Re: Mining moratorium: NWPR WOTUS and Army Corps on Okefenokee mine site

Exhibit I Modeling the GW Flow System Comments James L. Kennedy Ph.D., P.G.

Figure 22. Wetlands and Stream Channels

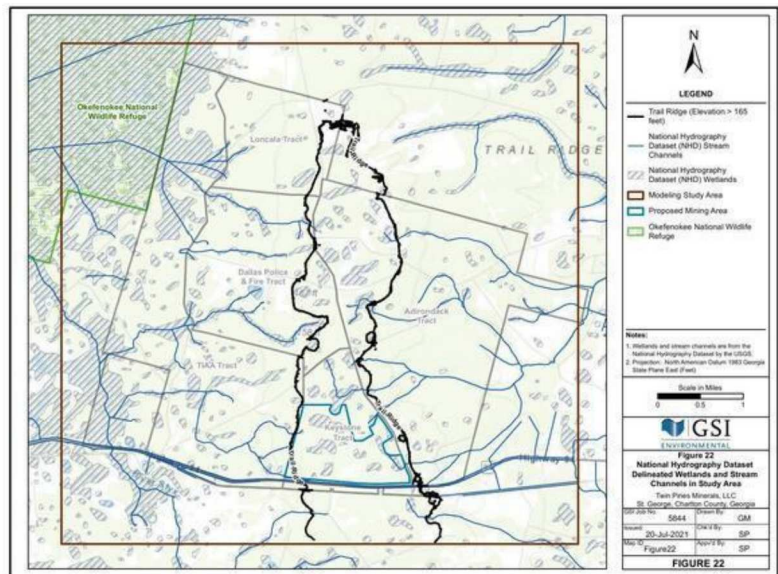
...  
**Page 8:** Explicitly explain what use of the drains versus rivers means in the model. In MODFLOW drains can receive water from the modeled aquifer but cannot recharge the modeled aquifer. A river can both receive water from the modeled aquifer and discharge water to the modeled aquifer.
